SUBJECT: Subcontract S005242-F
Dispositioned PPPL Major Tool & Machine Non-Conformance
Reports (NCR) 18830 and 18889

Attached are NCSX dispositioned Major Tool & Machine Non-Conformance Reports 18830 (Use as is) and 18889 (Repair). The dispositions were assigned by the Princeton Technical Representative Phil Heitzenroeder and approved by the Responsible Line Manager Brad Nelson.

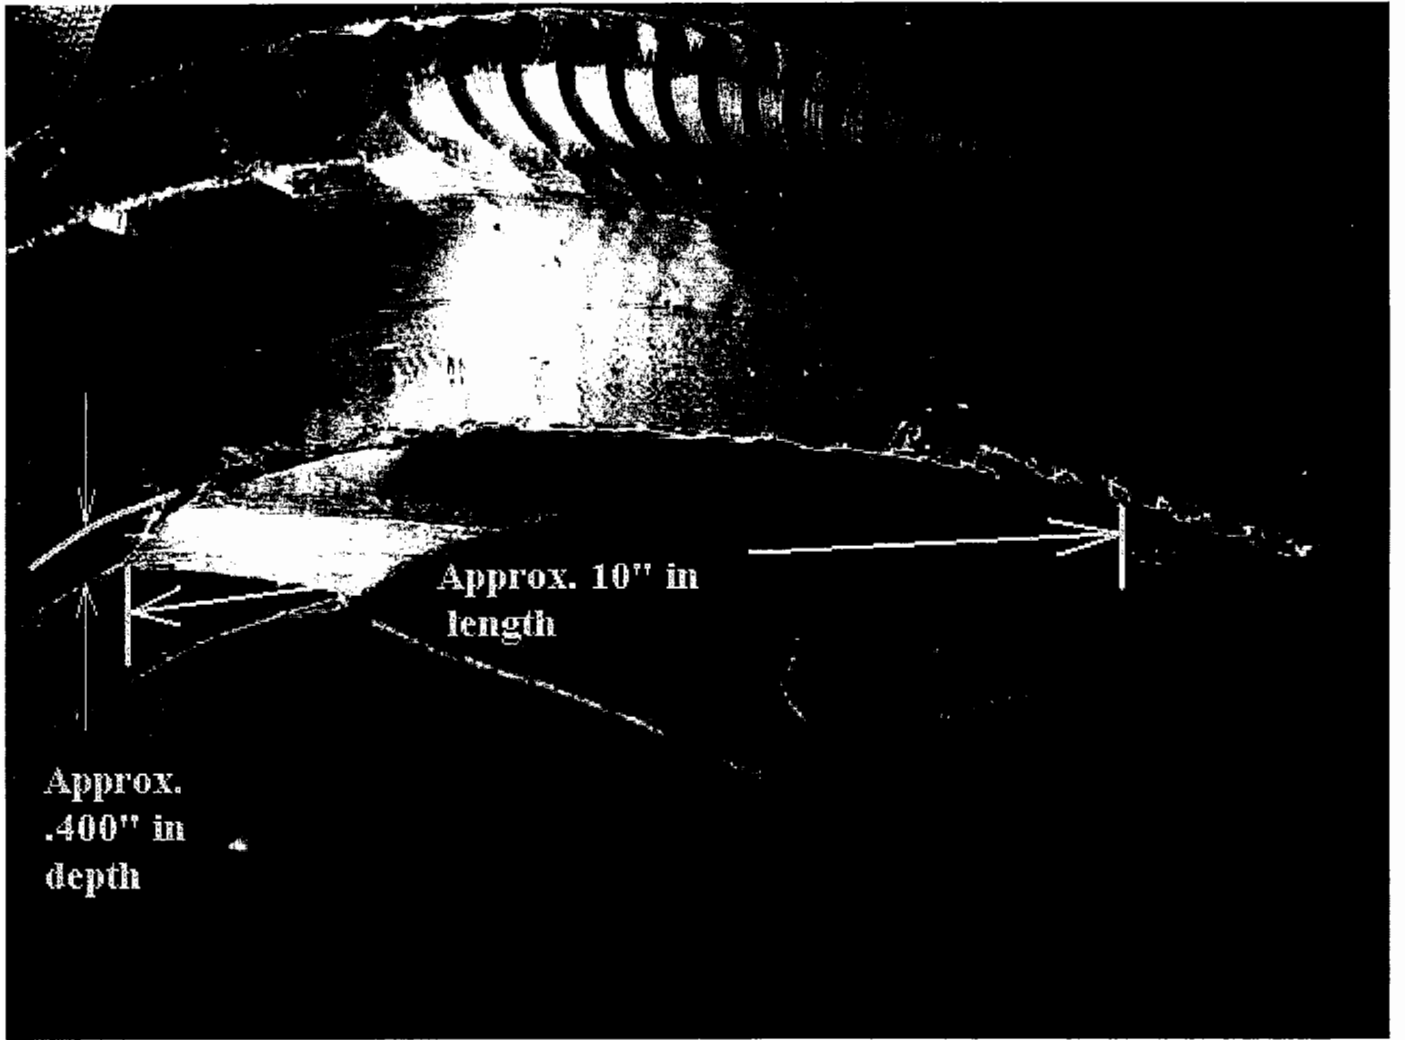
Problem: Reference sheet 6, section P-P. There is a tooling gouge on the top of the T approximately 10" in length. The gouge tapers from in tolerance to a depth of approximately .400" over the 10" span. See attached pictures for location.

Approx. 10" in
length

Approx.
.400" in
depth

RECOMMEND TO WELD REPAIR DAMAGED AREA AND REMACHINE.

This refers to C3. We agree with the recommended disposition to weld repair and re-machine the gouged area.
